WASHINGTON COUNTY, ARKANSAS  
County Courthouse

**SPECIAL MEETING OF THE  
WASHINGTON COUNTY QUORUM COURT**

Meeting- February 12, 2015  
Project- Rich Red Dirt CUP  
Project Number- 2014-124  
Planner- Juliet Richey,  
jrichey@co.washington.ar.us

## ZONING- CONDITIONAL USE PERMIT REQUEST

**Current Sight Distance information provided by the  
Appellant's Engineer, Mike, Kelly, P.E.**

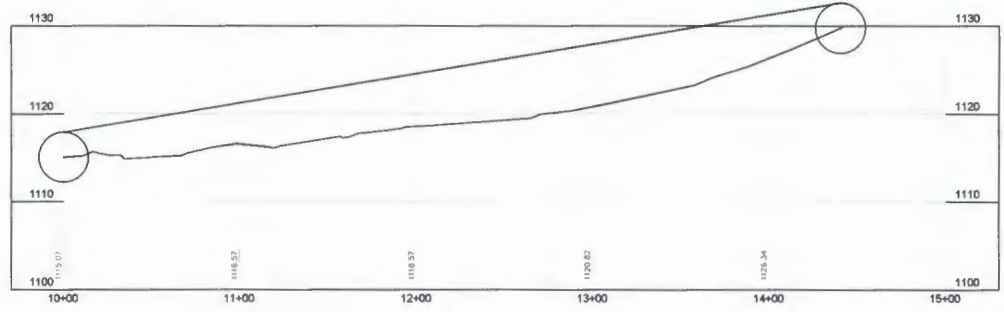
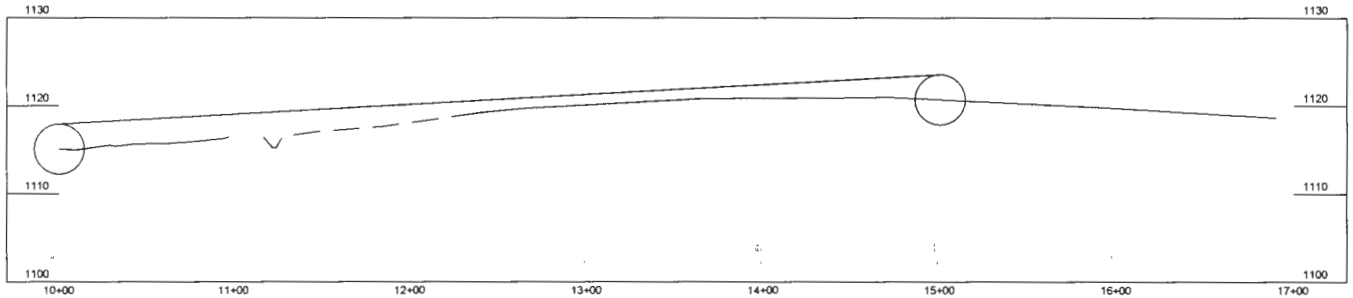
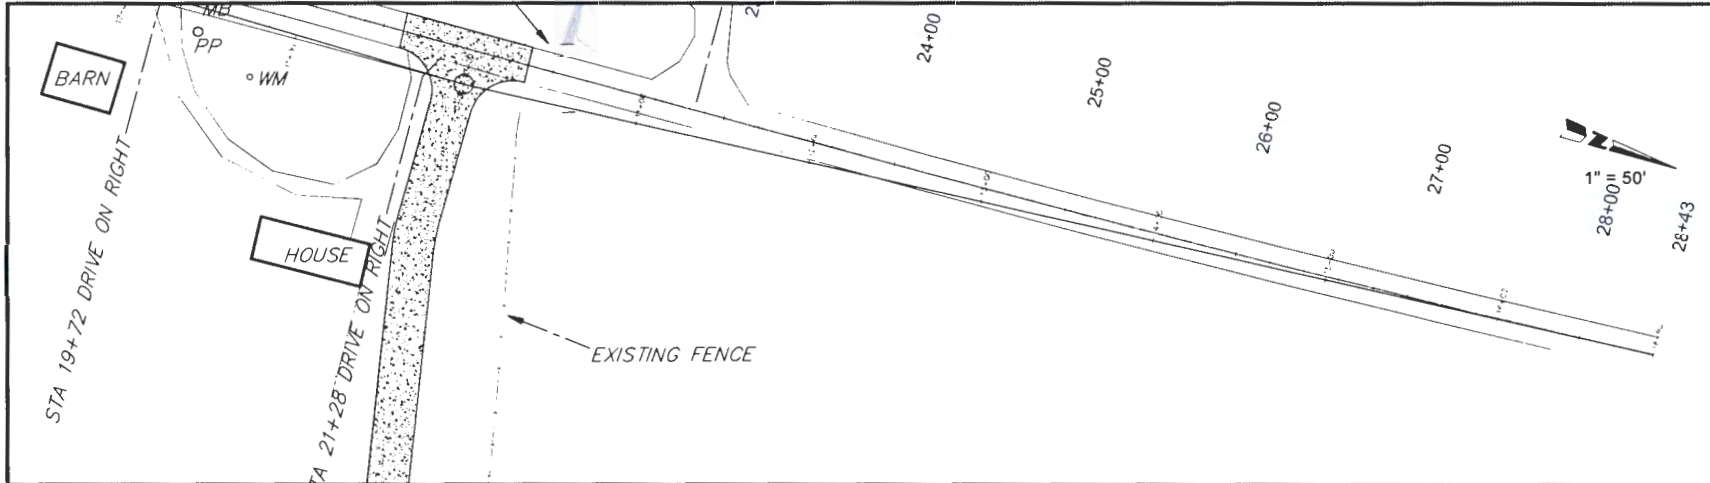
"Safety- All designs are set for 45 mph per zoning staff unless applicant could prove Harmon Road does not meet 45 mph design. Our engineer surveyed the site and stamped drawing stating that existing horizontal and vertical alignments for Harmon Road only meets 20 mph design. Immediately preceding the hearing, staff changed sight distance requirement from 500 feet (Current ordinance) to 628 feet (not a current Ordinance) without properly notifying the applicant prior to the hearing,"

1. Safety-All designs are set for 45mph per zoning staff unless applicant could prove Harmon road does not meet 45mph design. Our engineer surveyed the site and stamped a drawing stating that existing horizontal and vertical alignments for Harmon road only meets 20 mph design. **Immediately preceding the hearing, Staff changed sight distance requirement from 500 feet (Current ordinance) to 628 feet (not a current ordinance) without properly notifying the applicant prior to the hearing.**

Planning Staff had the County Contract Engineer analyze the initial information submitted by the applicant's engineer. The County Contract Engineer came up with different design speed calculations and did not come to the same conclusion (That the design speed of Harmon Road should be dropped). This information was conveyed to the applicant and their engineer prior to the November 6, 2014, meeting.

When using the value prescribed by the manual for truck traffic, the distances needed to provide for safety at an intersection increases. Using the time gap value appropriate for the proposed type of truck traffic at this site, Staff calculates that the sight distances needed (for left hand turning movements from the proposed Haul Road onto Harmon Road) should be as follows:

- **45 mph is the posted speed for this section of Harmon Road. The findings do not warrant a change in the posted speed of 45 mph for this section of Harmon Road.**
- **The proposed haul road does not have enough sight distance to safely make left turns onto Harmon Road. The minimum sight distance needed to make a left turn (from the haul road) onto a 45 mph roadway is 628 feet. According to the information submitted by the developer, the proposed site has a current intersection sight distance (from the location of the haul road looking south) of 446 feet.**

PLAN AND PROFILE  
 STA 10+00 TO STA 28+00

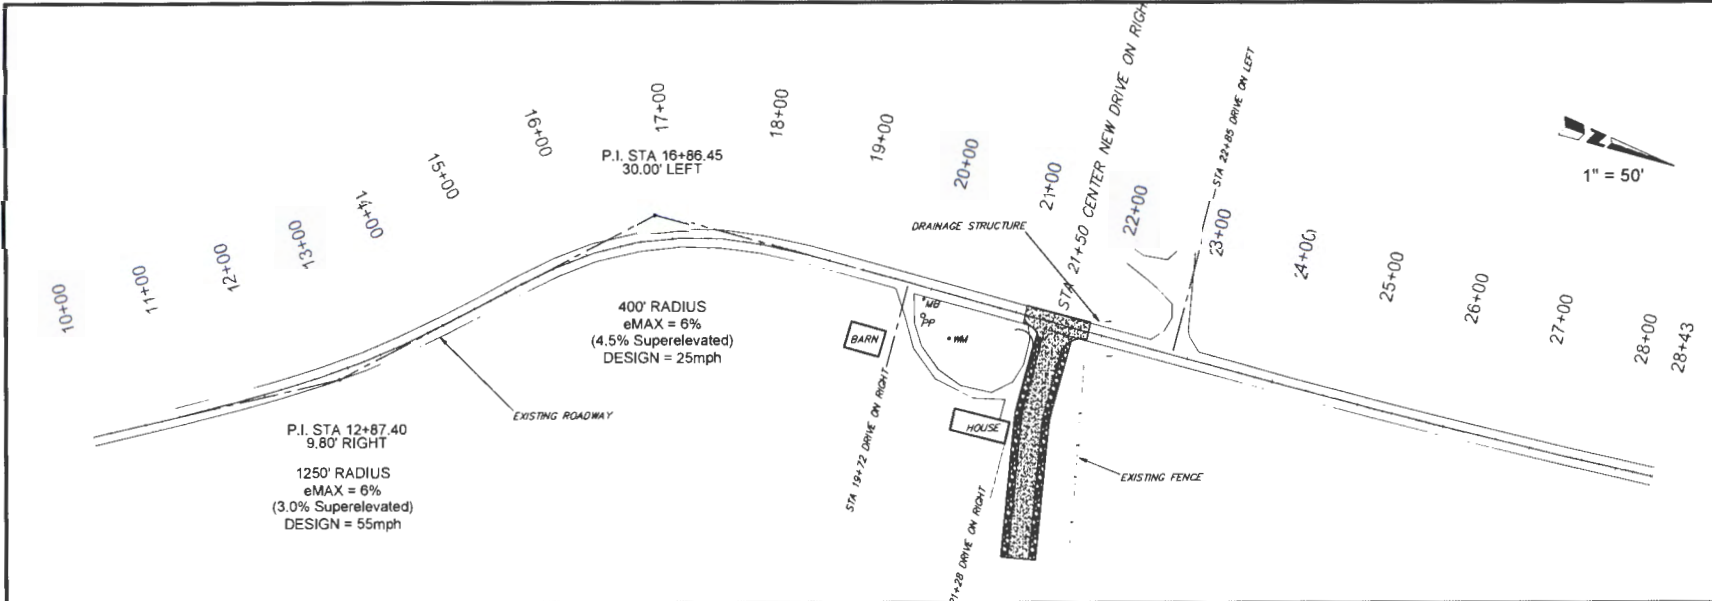
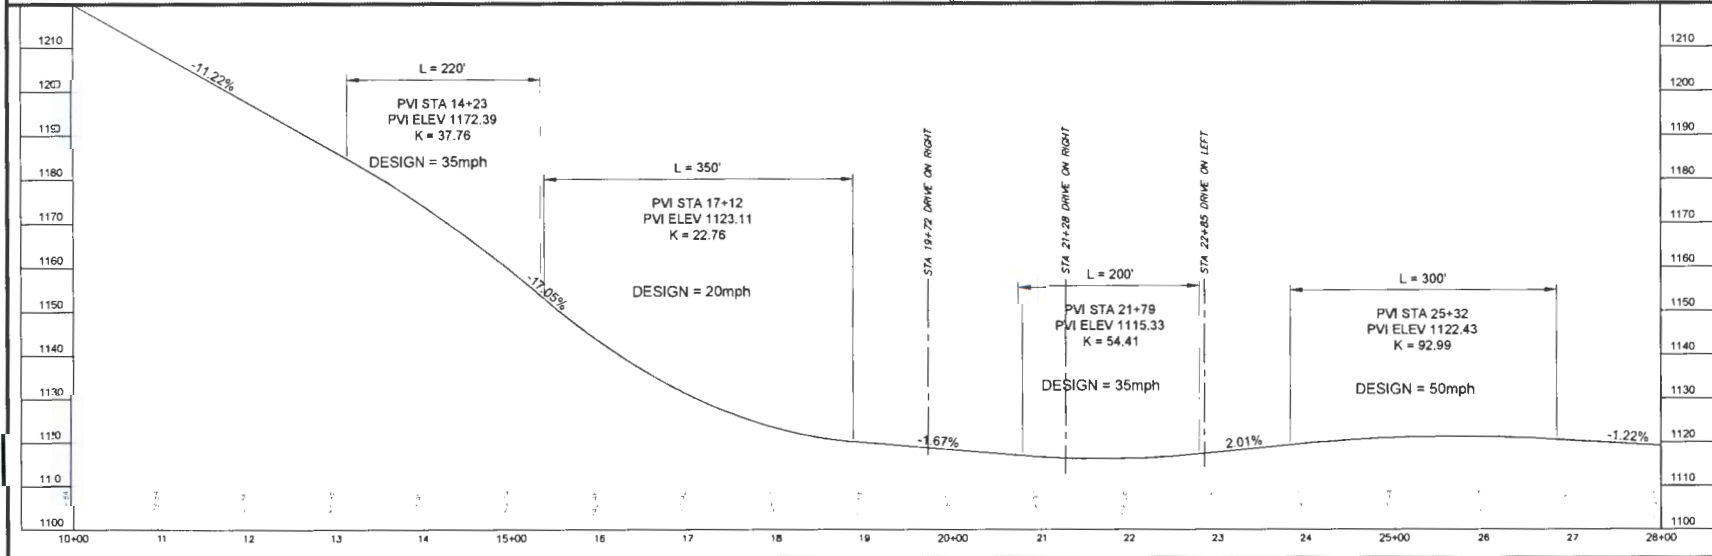
Planning Staff still has concerns regarding the lack or minimal width of proposed buffers onsite- especially in the area of the proposed Haul Road. The applicant has attempted to move the haul road away from the neighboring property line as much as they can, but the haul road is still within 35' or less from the neighboring property line for approximately 400'. While 28'-35' may seem like a substantial width of land, staff feels that with the impact of 100 dump truck trips per day further buffer may be needed for surrounding properties. The applicant has also offered to place a 3' berm (with cedar trees on top of it) for the first 230' along the haul road. Staff feels that a berm could be effective, but feels it should likely be taller than 3' in height and extend to at least 400' in length. Additionally, the location of the berm should be considered carefully, as none of the existing fence line vegetation should be disturbed (so that the existing vegetative screen remains in place).

County Staff is concerned about this issue- especially due to the amount of traffic that currently travels Harmon Road. The applicant has specified that they will build a tire wash onsite to help mitigate this issue, but this is not shown on the current plans (that staff can see).

**Letter and Plan/Profile information regarding the  
applicable section of Harmon Road from  
Washington County Contract Engineer, Clay Grote, P.E.**

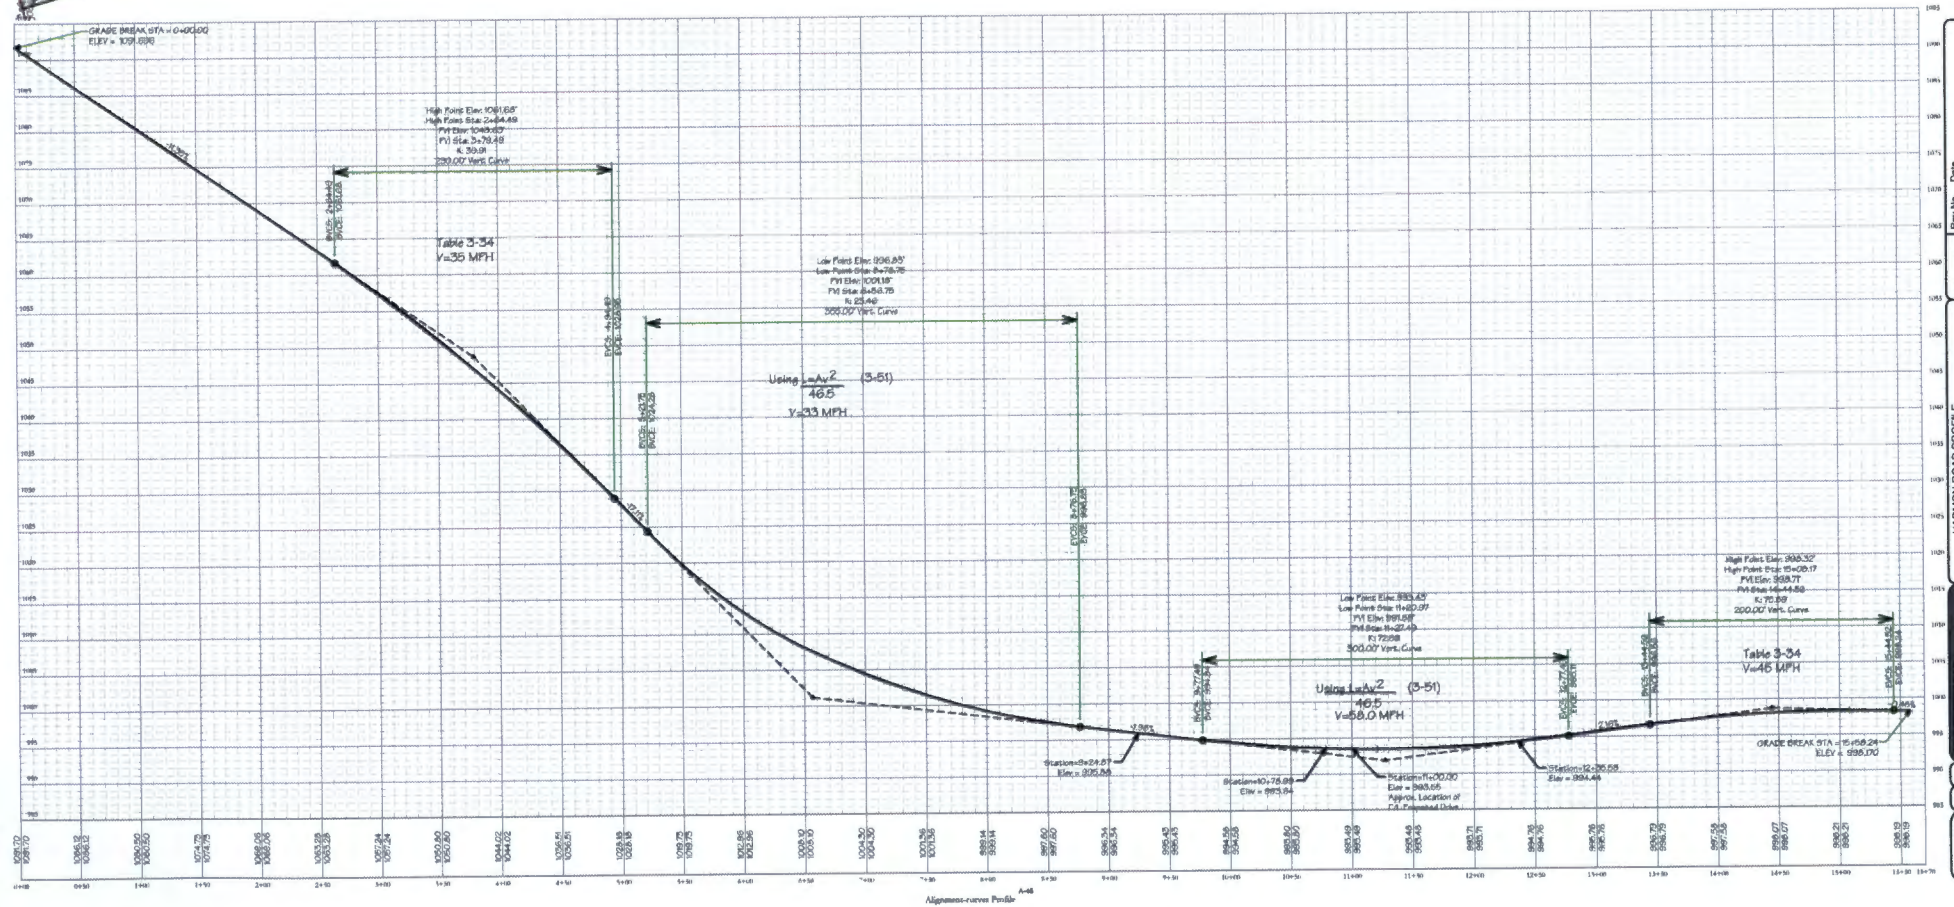
25 mph. The portion of Harmon Rd. to the north of the site yields a design speed equal to the posted speed of 45 mph. In conclusion, after analyzing the existing roadway with the location of the proposed drive, it is my professional opinion that the findings do not warrant a change in the posted speed at the section of Harmon Road.

The basis of all these calculations is to determine the appropriate sight distance for the intersection of Harmon Road and the proposed drive location of the site. Since this is a proposed red dirt pit, the traffic leaving the site will primarily be single-unit trucks. According to the Green Book the time gap for a stopped single-unit truck to turn left onto a two-lane highway with no median and with grades less than 3 percent is 9.5 seconds (Table 9-5). Using equation 9-1 for determining sight distance, the site distance needed to make a left turn onto a 45 mph roadway is 628 feet. According to the submittal provided by the developer, the proposed site has an intersection sight distance of 446 feet. In conclusion, the proposed drive of the proposed does not have enough sight distance to be able to safely make left turns onto Harmon Road.

**c. Rich Red Dirt CUP- approximate sight distance for left turns onto Harmon**  
**(looking south)**

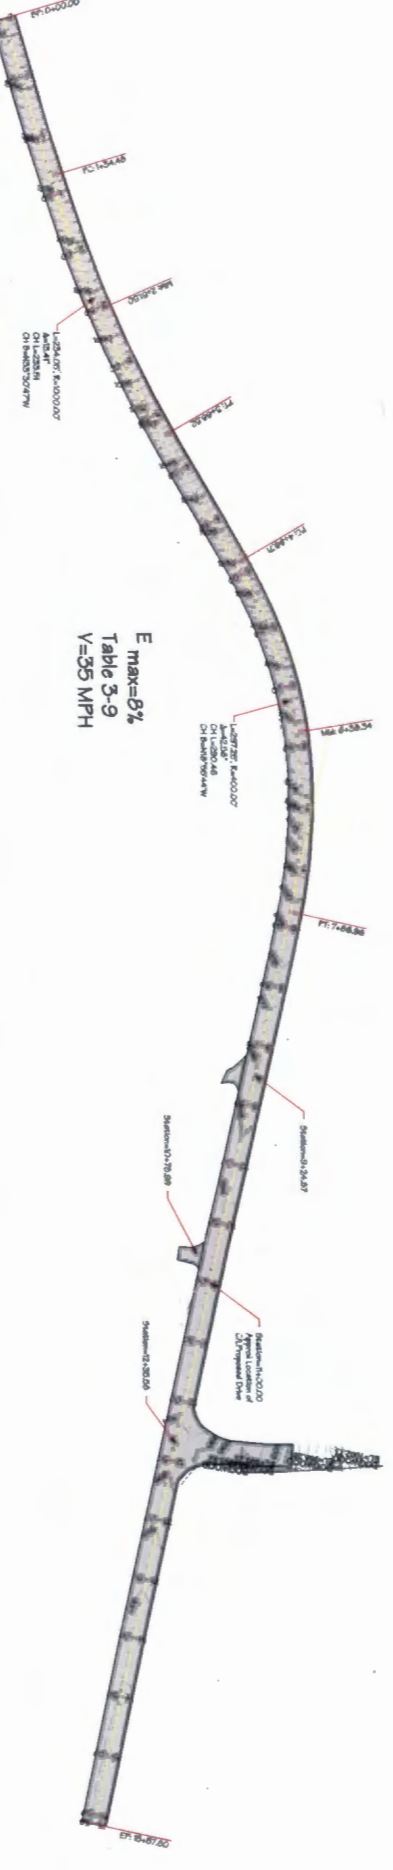
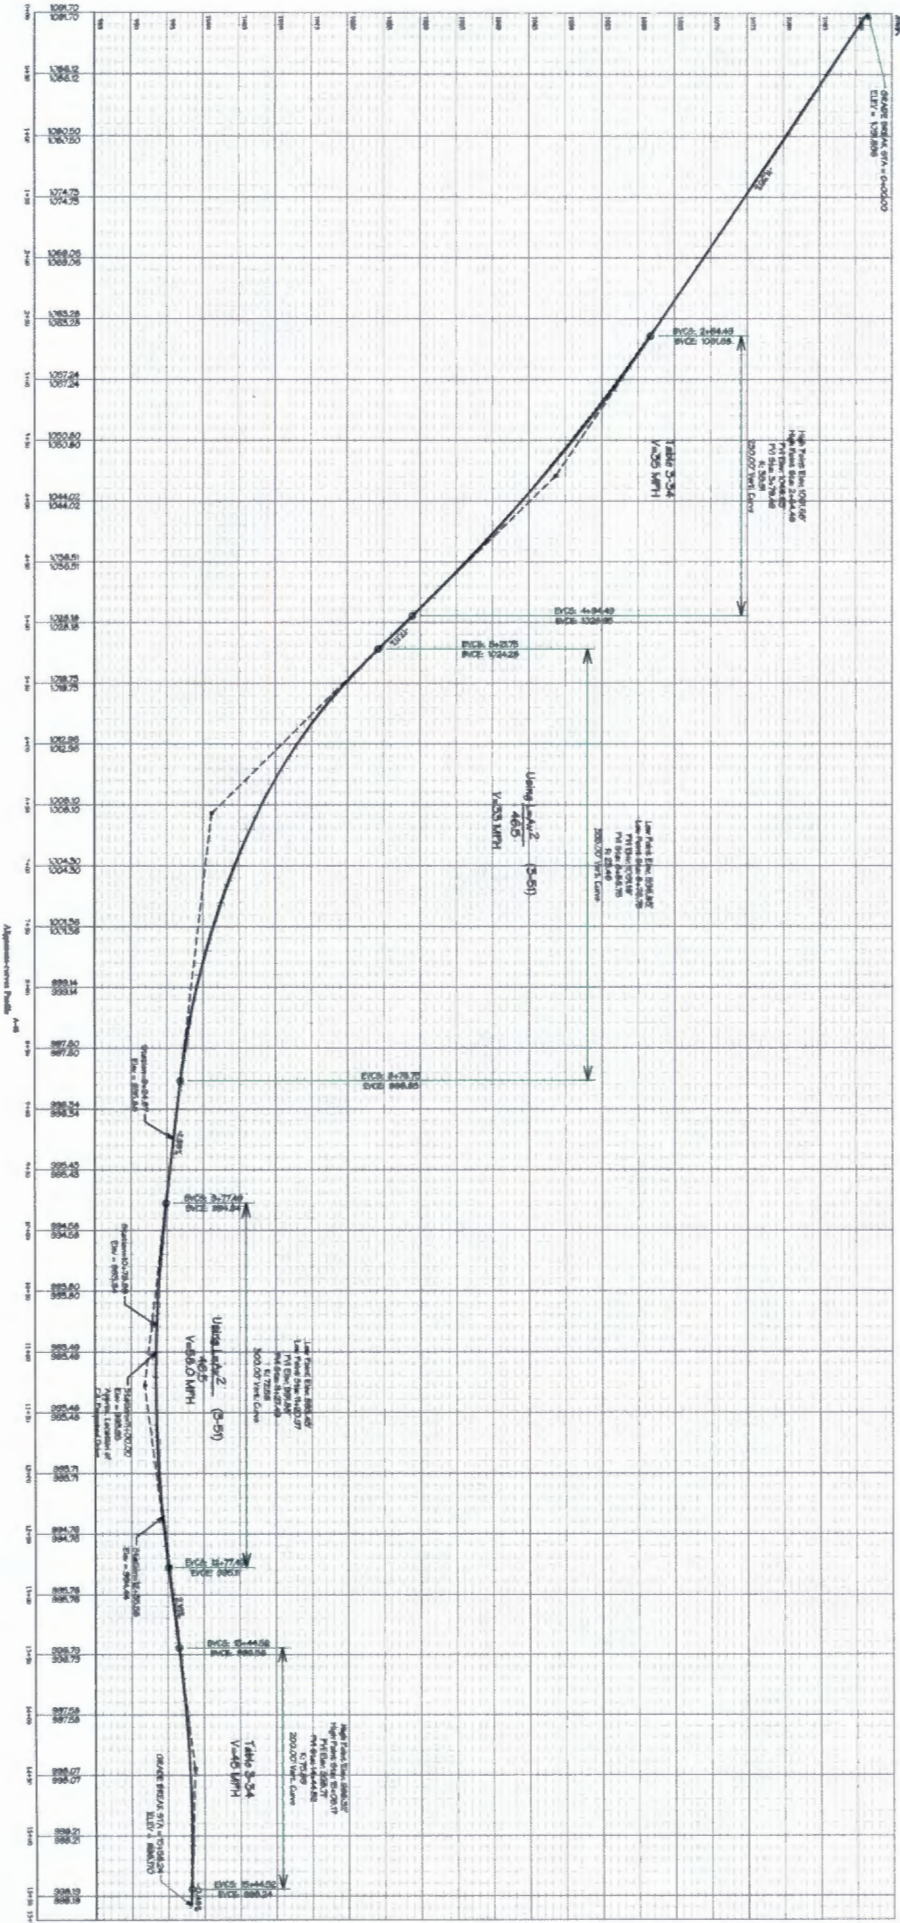
concerns were in regard to the location that a photo that you had attached was taken. The photo appeared to be taken from the center of Harmon Road- not where sight distance would be measured from. As per our Engineer, there is a certain procedure for determining sight distance as per the AASHTO green book. We need you to provide proof that sight distance was determined (for both left and right turns onto Harmon) as per these standard engineering methods.

In addition, the photo you submitted regarding sight distance appeared to be taken by someone standing near the center of Harmon Road, not at the location of the actual intersection where sight distance would be obtained. I would like assurances that any measurements you are taking are taken from the exact locations that they should be and that you are calculating the distances from the heights required for such calculations. Please provide written documentation of these measurements and the exact locations and heights which the measurements were taken. Please state these measurements from both directions and include commentary on the vegetation on/near your northern property line as well.
